RAI 5:

Response to Request for Comment on Draft Safety Evaluation for AREVA Inc. Topical Report EMF-2328(P)(A), Revision 0, Supplement 1, Revision 0, "PWR Small Break LOCA Evaluation Model, S-RELAP5 Based" (TAC No. ME8227)

EMF-2328(NP)(A)
Revision 0
Supplement 1
Revision 0

PWR Small Break LOCA Evaluation Model,
S-RELAP5 Based

Figure 5-17: Break Mass Flow Rate – W 4-Loop

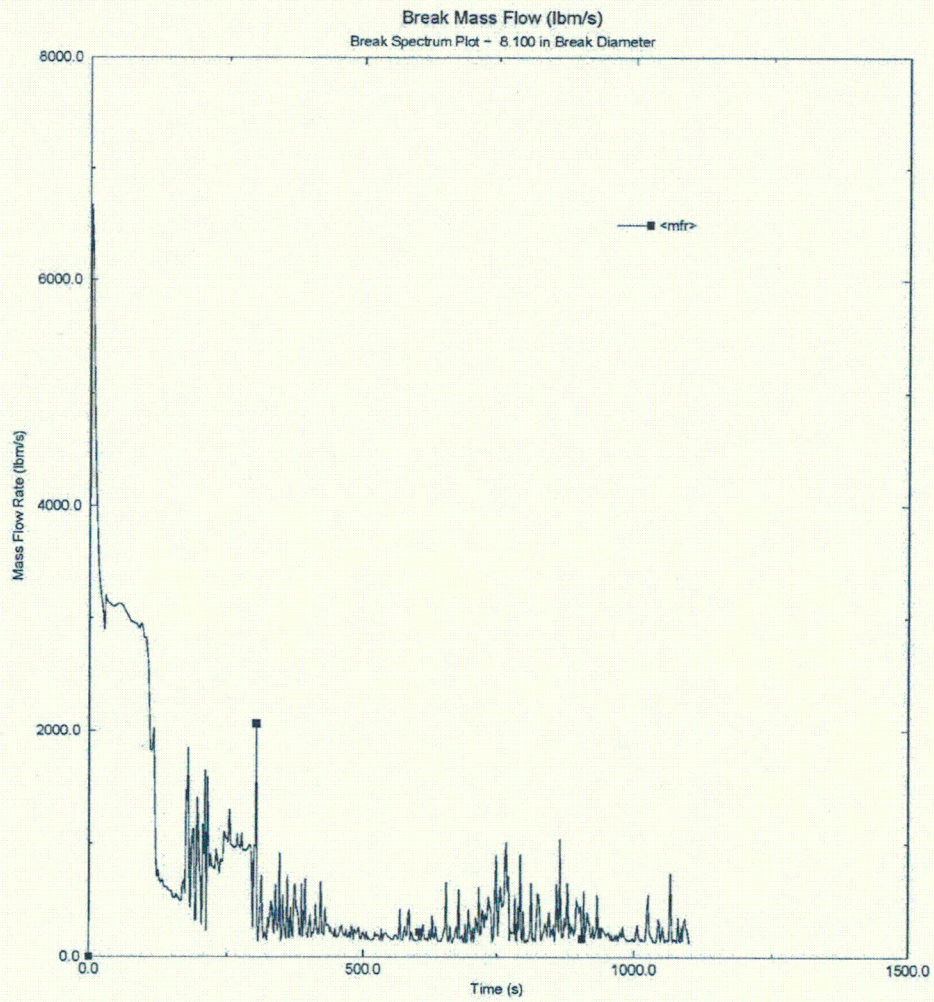
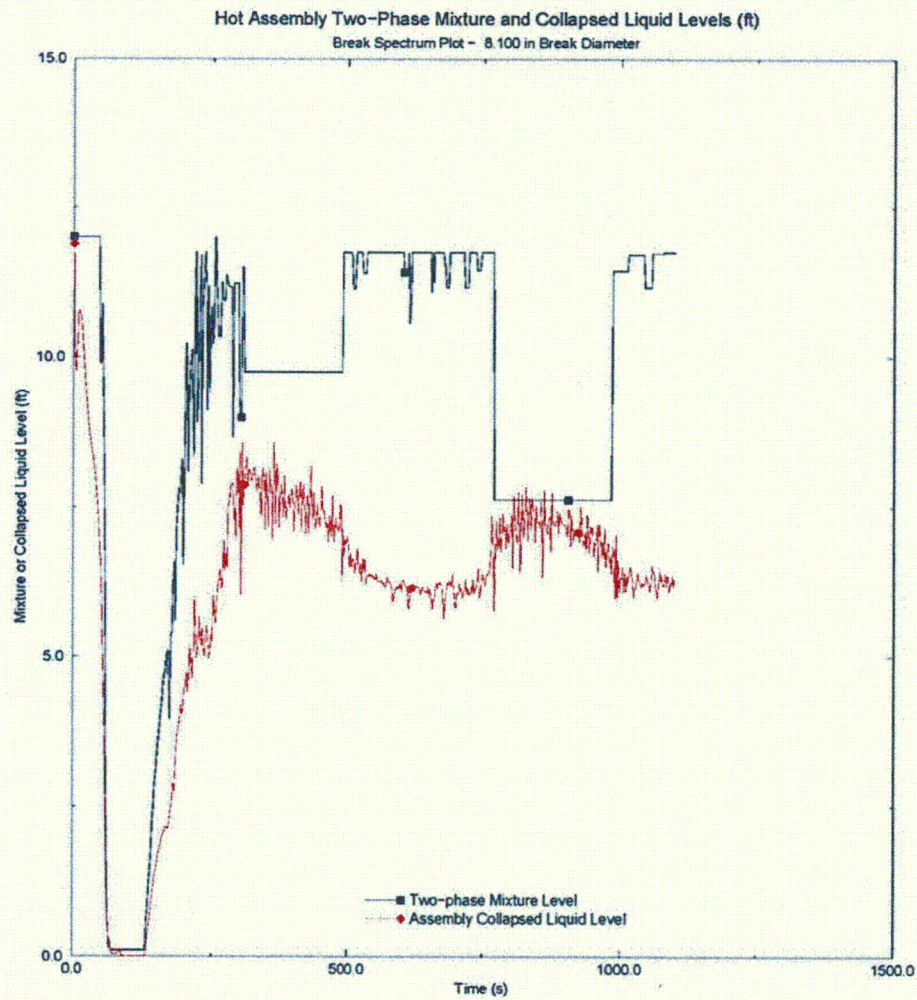
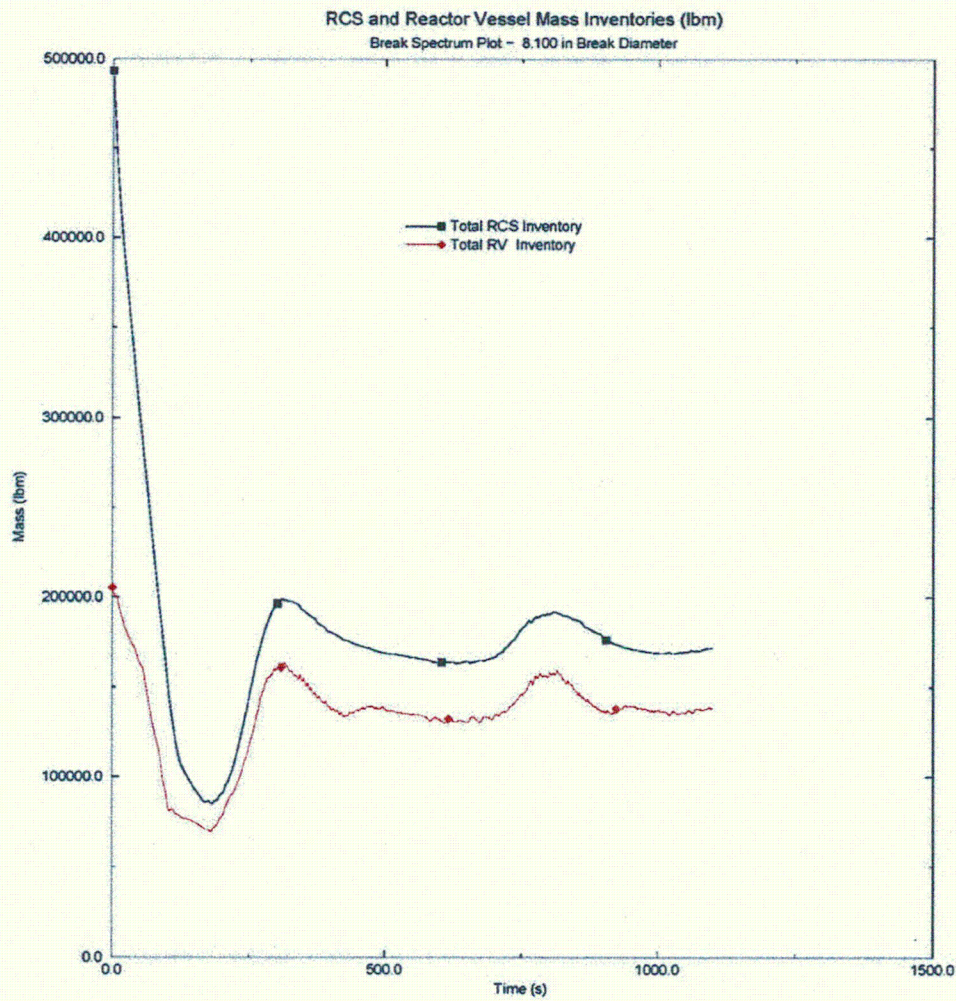
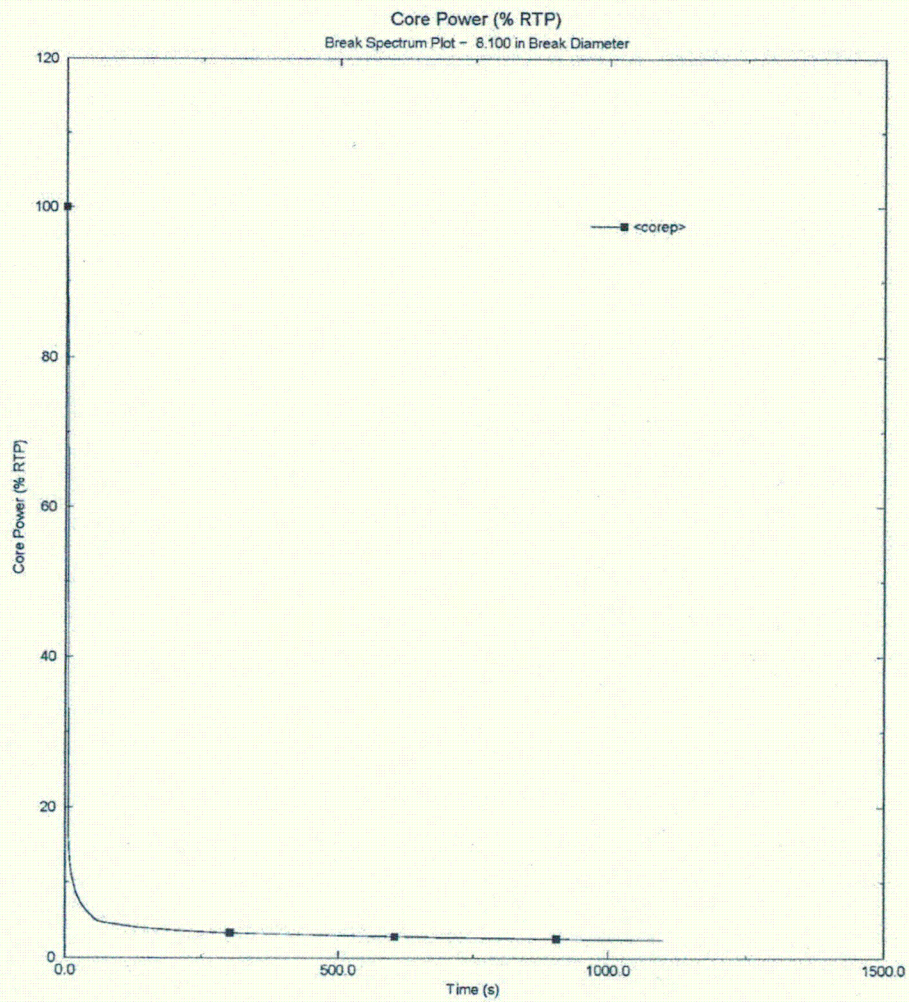
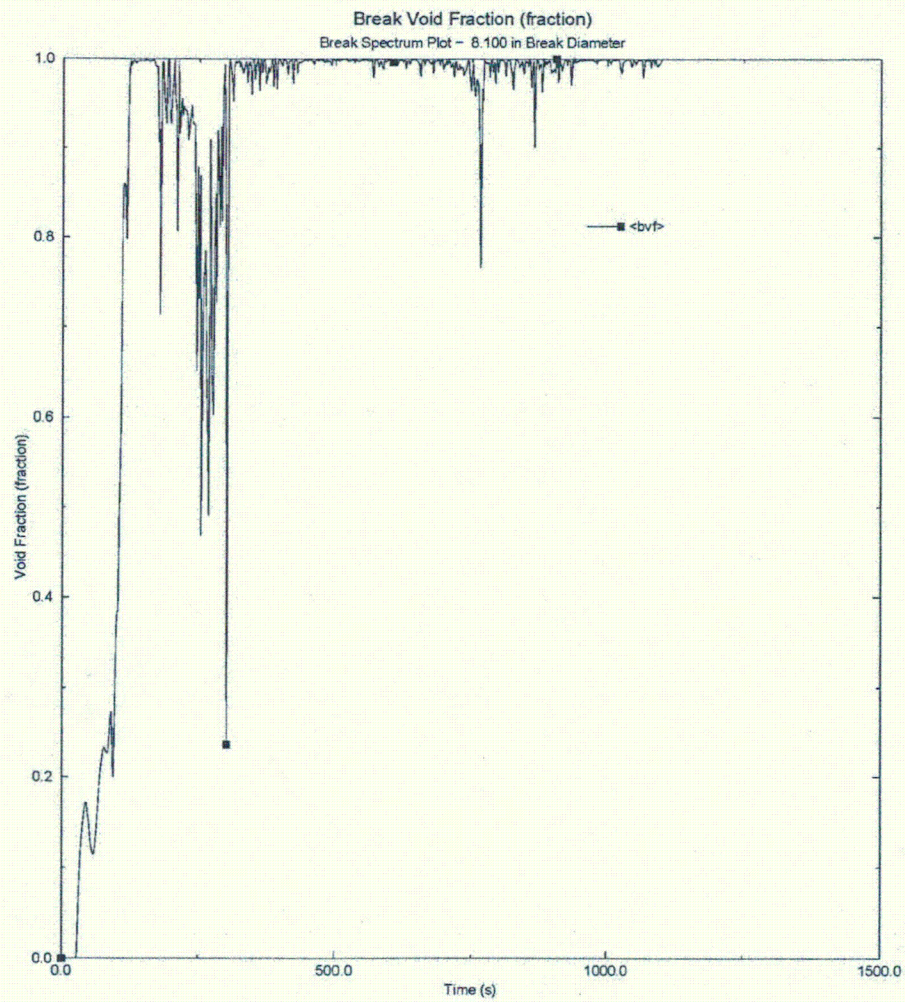
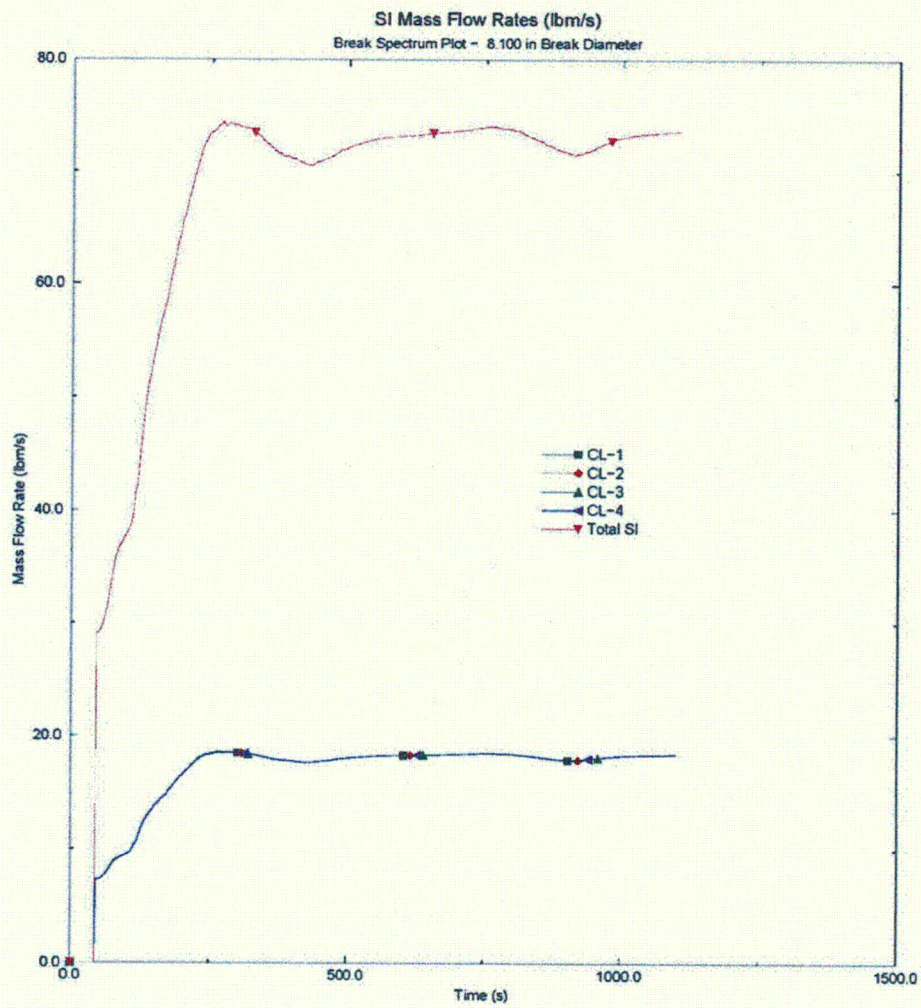
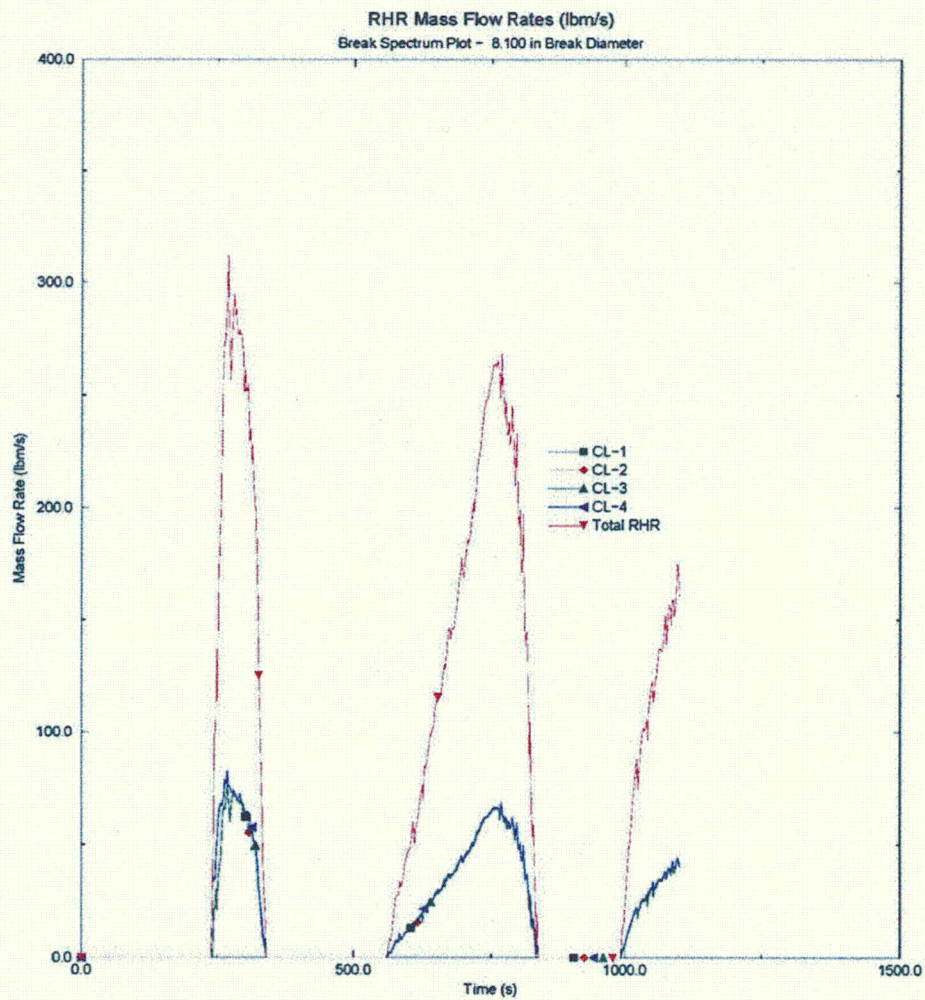
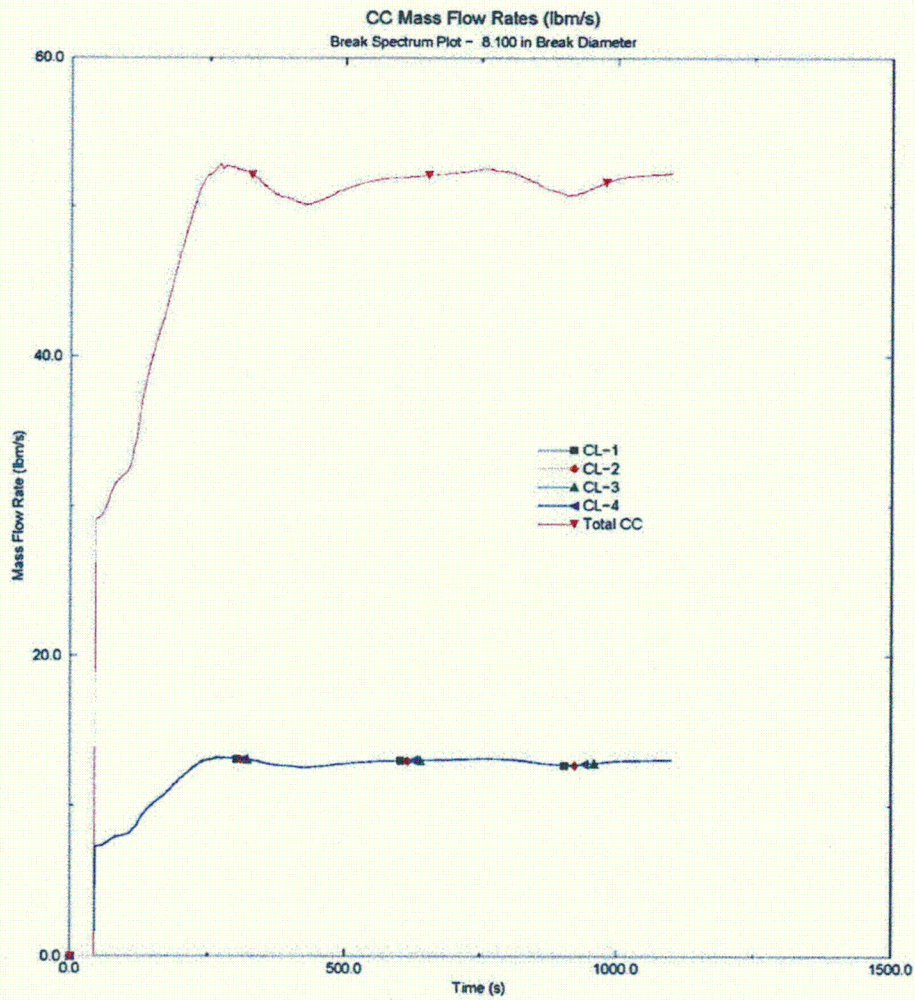
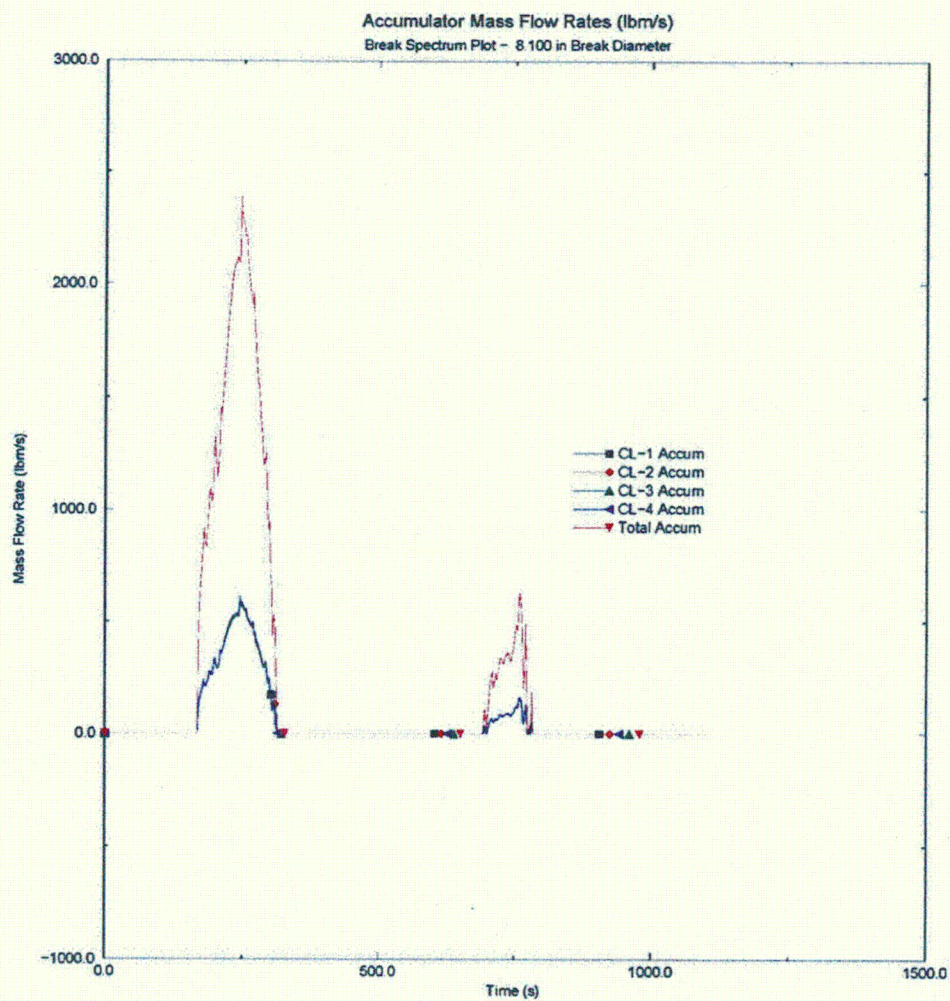
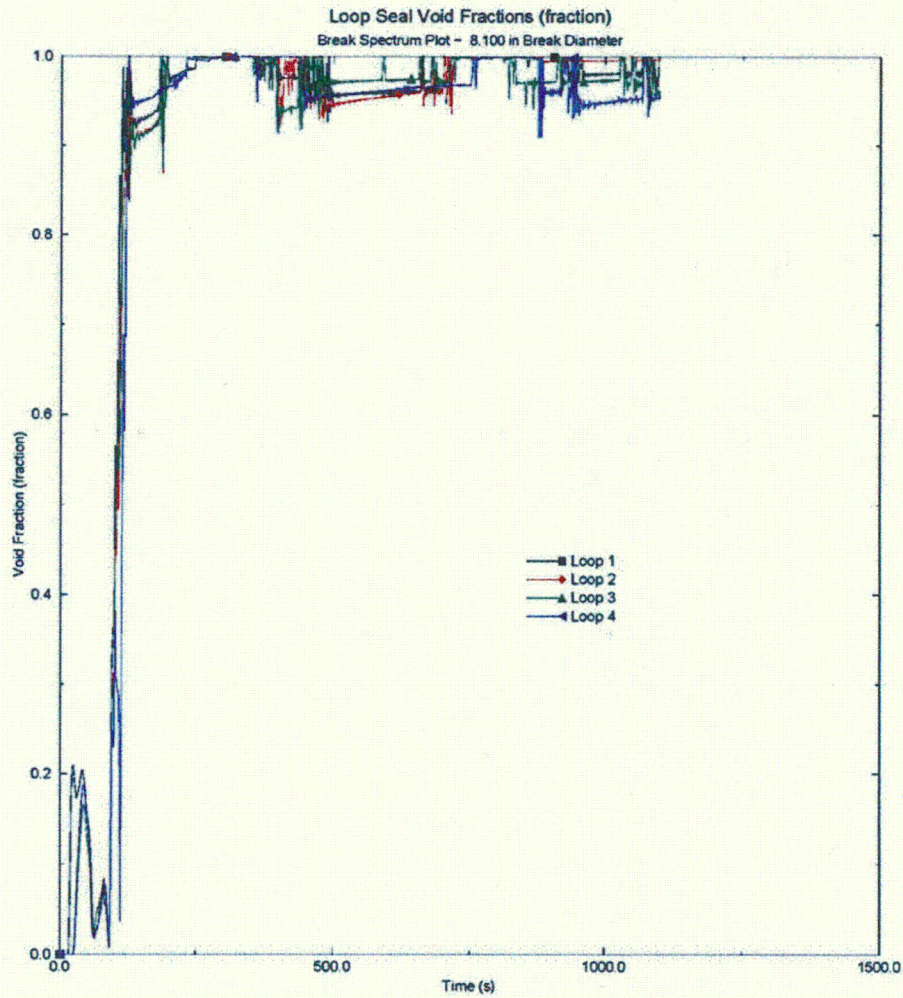
Please provide a plant sample break spectrum analysis with all of the EMF-2328(P)(A), Revision 0, Supplement 1, Revision 0, changes included. This could be accomplished by comparing the results of a sample plant SBLCOA spectrum with and without the EMF-2328(P)(A), Revision 0, Supplement 1, Revision 0, changes. This should include the severance of the safety injection line, as well.

The limiting break for a CLPD break and an accumulator line break are presented in Table 5-7 and Table 5-8, respectively. The results from the break spectrum analysis are presented in Table 5-9. The limiting PCT is 1429°F for a 8.10 inch equivalent pipe diameter break size. A listing of the sequence of events for each break size in the spectrum is shown in Table 5-10a through Table 5-10d. Plots of some of the more important parameters for the limiting break of 8.10 inches are presented in Figure 5-17 through Figure 5-34.

A double ended break in the accumulator piping connecting to the RCS does not produce a limiting case. An acceptable amount of emergency core cooling flow is delivered to the intact loops.
